Appendix 2 – Proposed Plan Chapters (Chapter 6A Objectives and Policies: Tara-Ika Multi-Zone Precinct and Chapter 15A Rules: Tara-Ika Multi-Zone Precinct) and Structure Plan with recommended changes annotated

Appendix 4 – Right of Reply – Tim Kelly – Transport

Date:	3 December 2021
Project:	Tara-Ika PC4
Subject:	Transportation Issues: Comments for Right of Reply

Appendix 5 – Right of Reply – Daniel Males and Graeme McIndoe – Urban Design and Landscape

Figure 1: Cross-town connectors: Queen Street East at top, Liverpool Street/Mako Mako Road alignment through the centre of Tara-Ika

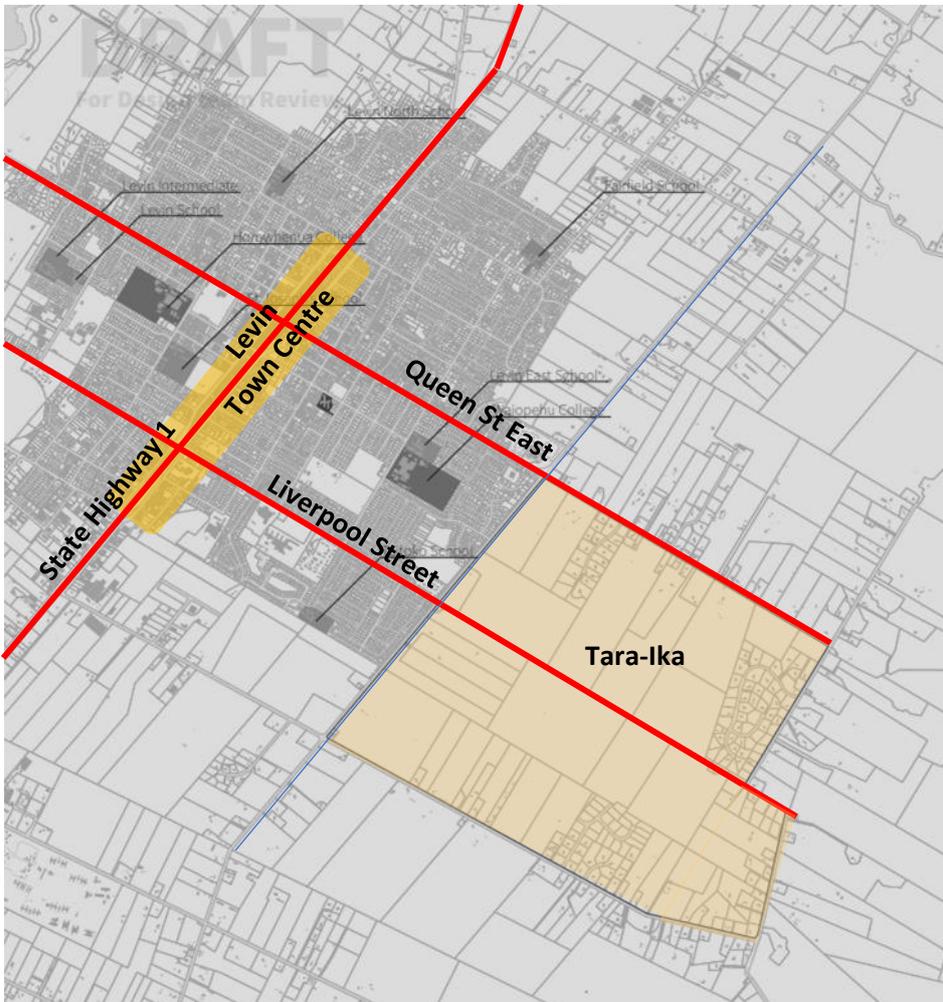
- e. Develop a logical and coherent interconnected network of streets and movement links for easy navigation and wayfinding.
4. An interconnected and coherent urban structure is one of the fundamentals of good neighbourhood planning and the Liverpool Street alignment allows connection into the wider urban structure of Levin: Liverpool Street (which becomes Mako Mako Road north of SH1) and Queen Street are the principal east-west streets that extend fully across Levin. The Tara-Ika neighbourhood is centred on Liverpool Street, so from a whole of Levin spatial structure planning perspective, Liverpool Street provides the logical alignment for connected growth extension, as recognised by both the masterplan and the structure plan. (Refer to figure 1 below.)

5. East-west connection to Arapaepae Road on the alignment of Liverpool Street allows a Liverpool Street connection to be established in the future. Should immediate connection though to Liverpool Street not be made, there is no need for further alternative connection west of Arapaepae as these are already planned for and/or in place. Tara-Ika would connect to Arapaepae Road on the main east-west connector aligned on Liverpool Street and from there connection would be to Perth Street in the south and via the existing street connection at Meadowvale Drive in the north. Both of those connections are shown on the masterplan.

Figure 3: Residential extension east of Arapaepae Road with potential O2NL in place

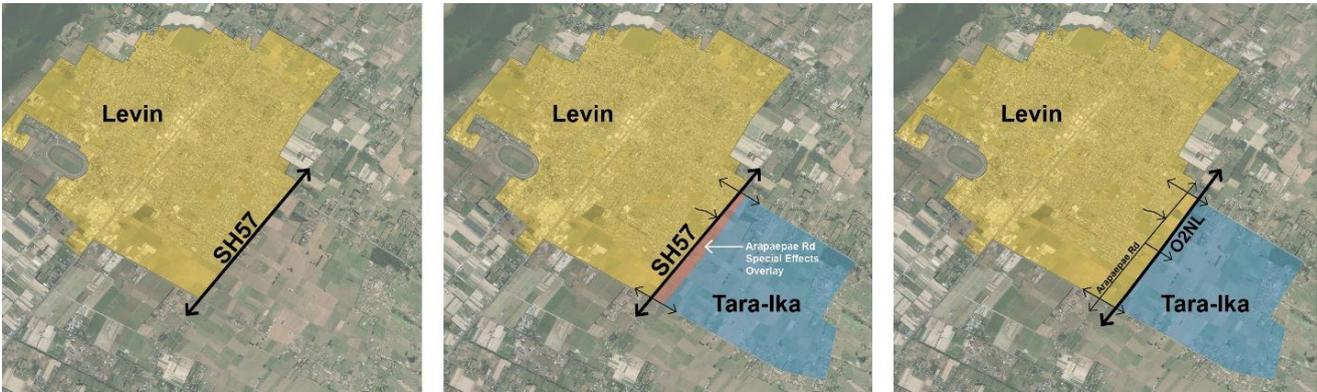
- 17. There is currently residential next to the 100kmh, Arapaepae Road. Prior to construction and commissioning of any O2NL, Arapaepae Road continues as a state highway, and acoustic amenity is provided for with the proposed Overlay. There will not be both a state highway to the west of this area and the O2NL expressway to the east. Should the O2NL proceed and Arapaepae Road becomes an urban arterial rather than a state highway this area becomes an extension of the existing residential area of Levin. Refer to figure 3 below:

- 18. The left-hand image shows the current situation with SH57 forming a boundary to urban Levin. The centre image shows Tara-Ika in place with the Arapaepae Road Special Effects Overlay. The right-hand image shows how, should the O2NL proceed, the urban area of Levin extends across a ‘detuned’ Arapaepae Road to the O2NL. The Overlay may remain in place but is not shown in this image.

Figure 5: Indication of the impact / integration of a high voltage electricity corridor through Tara-Ika

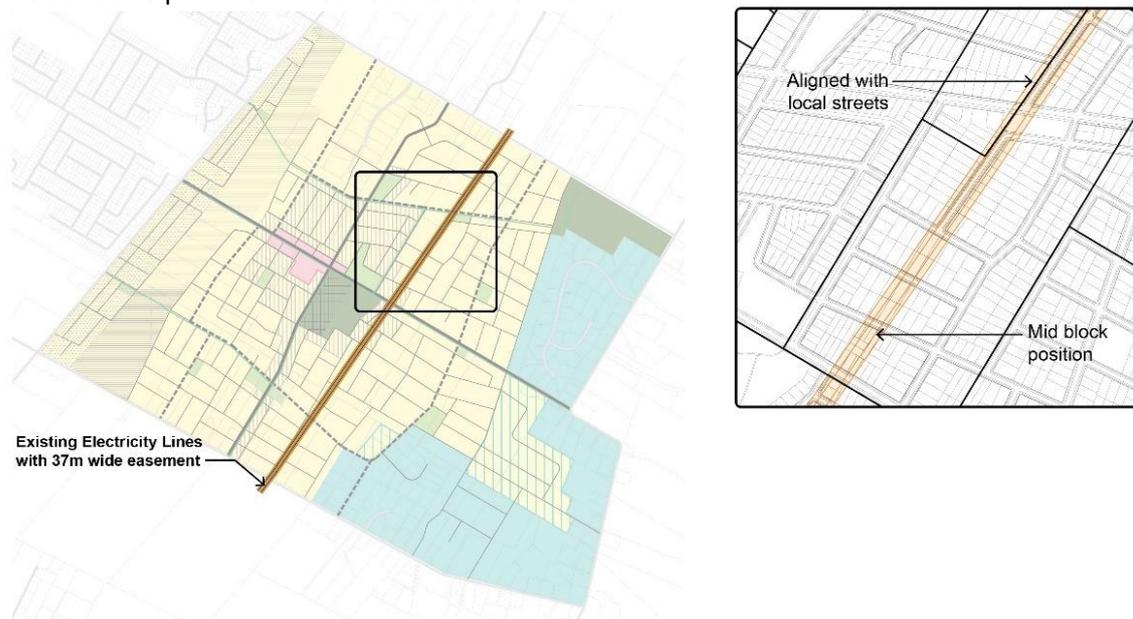
31. Our initial review demonstrates that 7.5 ha of land is directly affected by a 37m easement (refer to figure 5 for location, alignment and example of typical detail). Several local streets are aligned with the corridor and allowing for no-build zones on large lots, based on the current masterplan around 162 sections would be affected. However with some reconfiguring around 60-70 residential lots would be lost by allowing for a specific corridor. The corridor may also be in a mid-block location. It could run over deep or very large private lots with the no-build setback areas running through these. This mix of methods allows multiple masterplan options.

32. In considering Tara-Ika as a whole, should the lines remain overground, it is likely that all of the above approaches would be used. How such a solution would be delivered would be worked through with current landowners and with Electra. The structure plan would not need to be modified.

Figure 8: Introduction of a larger area including the Maunu Wahine refuge

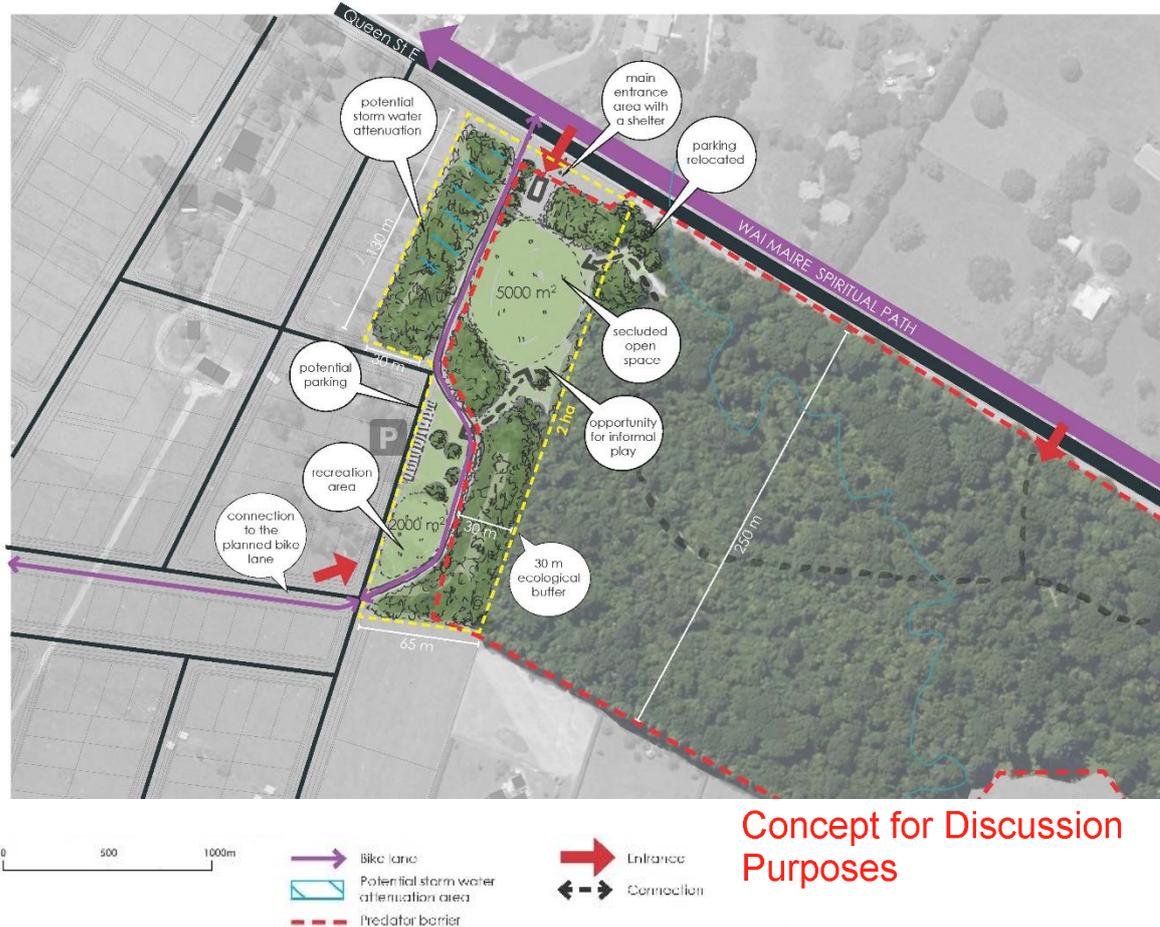
40. Follow the hearing adjournment on Friday 19th of November 2021 HDC and Dan Males met with Siobhan Karaitiana on the 29th November via teams. Local subsequently produced the following diagram (Figure 8 below) which shows a 2 hectare area and indicates how that area might accommodate a range of cultural, recreational and ecological initiatives.

41. This includes a central 'secluded open space' of 5,000m² which we consider to be generously scaled. For comparison, an area of 5,000m² is similar to the large open spaces that are part of some culturally significant large city parks. Figure 9 below shows from left to right Wellington's Waitangi Park, the north-east quadrant of Palmerston North's Te Marae o Hine/The Square and Pukeahu, the National War Memorial Park, also in Wellington.

Figure 10: Road cross-sections extracted from page 12 of the masterplan

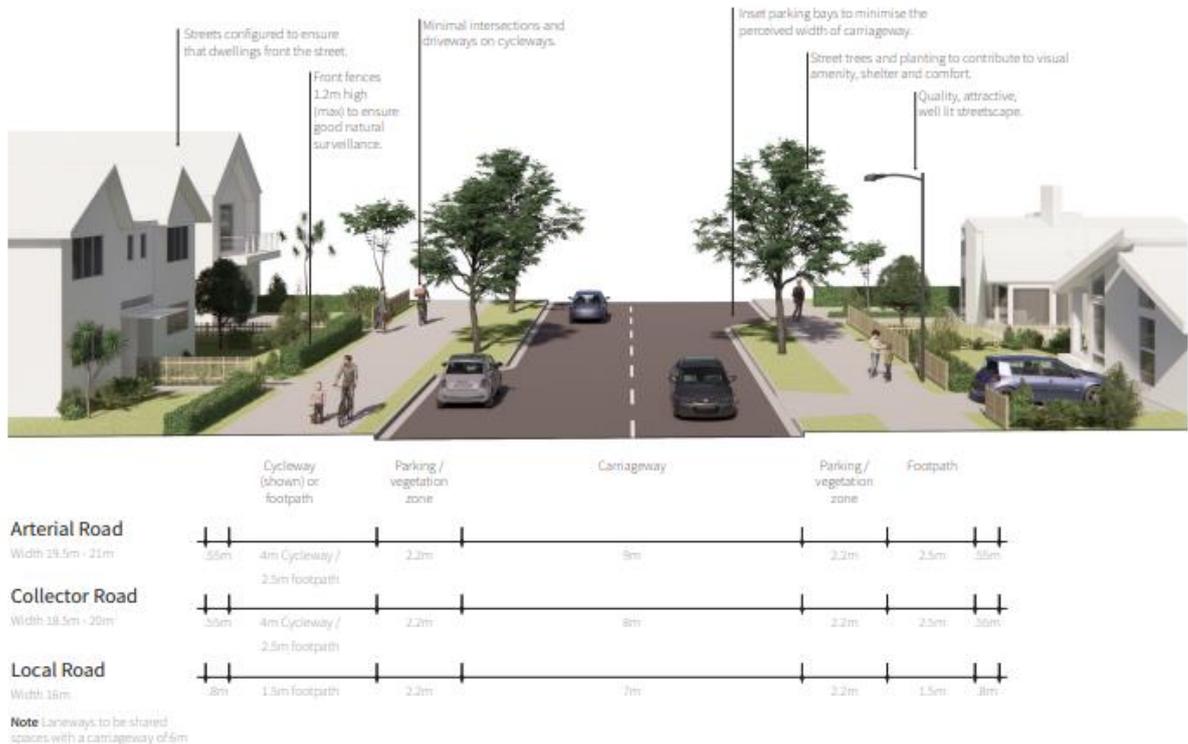
43. Figure 10 (from page 12 of the masterplan) identifies the width of the collector road which, because it does not include a cycleway is 18.5m wide. This is similar to the 16m width of a local road. The cross-sectional differences are:

Figure 1 Runoff routing diagram for existing conditions at Queen Street/SH57 intersection

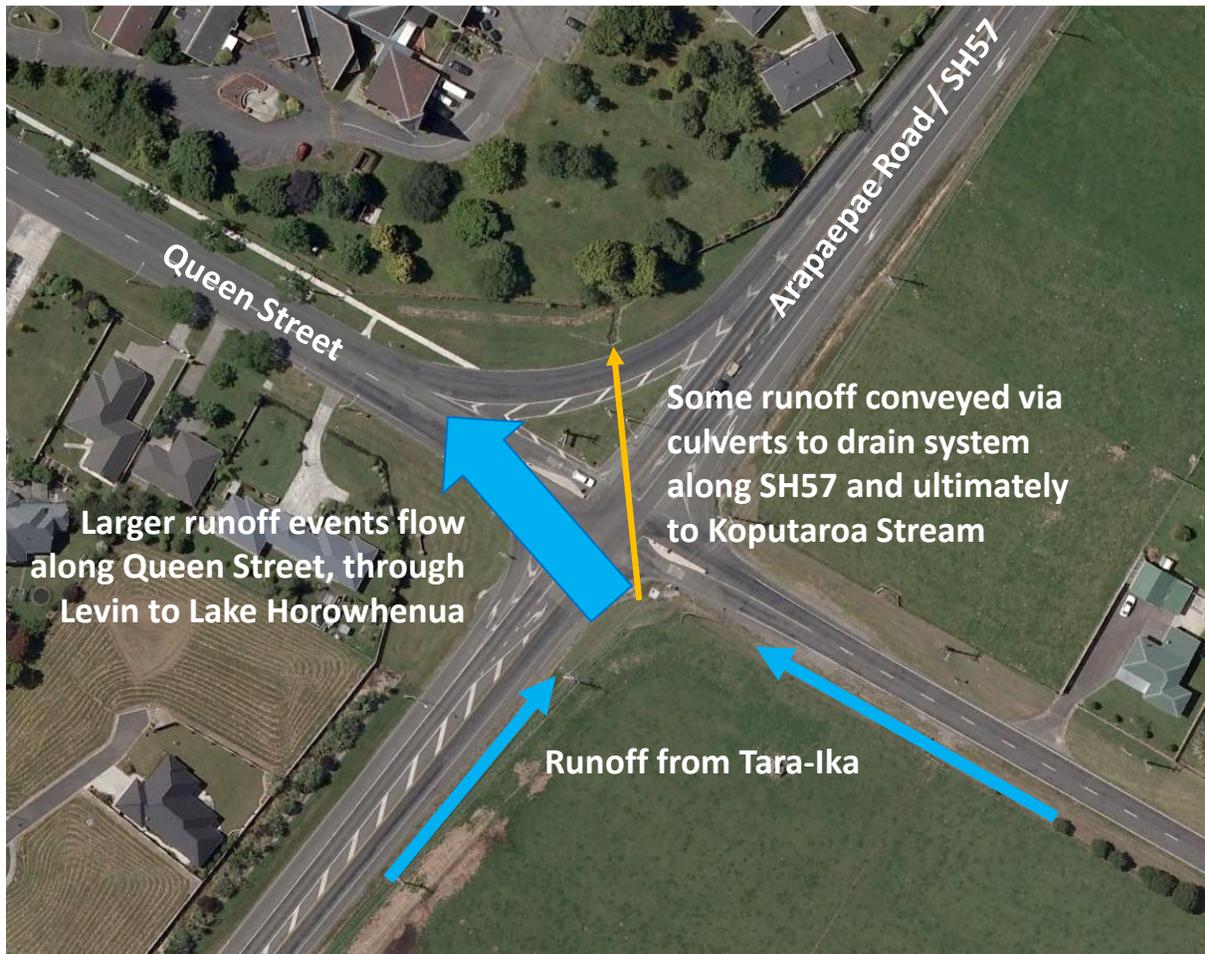
- i. Only a portion of runoff from the Plan Change 4 area is currently directed to a downstream watercourse (shown as the yellow arrow in Figure 1)
 - ii. Overland flows from Plan Change 4 are directed along Queen Street to Lake Horowhenua (shown as the large blue arrow in Figure 1); this is supported by the assessment of overland flow routes in the Plan Change 4 area that was completed as part of the preliminary stormwater management plan for Tara-Ika (GHD, 2020), and shown in Figure 2

- d. Considering these points, the currently proposed stormwater performance criteria to retain and soak all runoff up to the 100-year ARI rain event, including the effects of climate change, should be maintained.
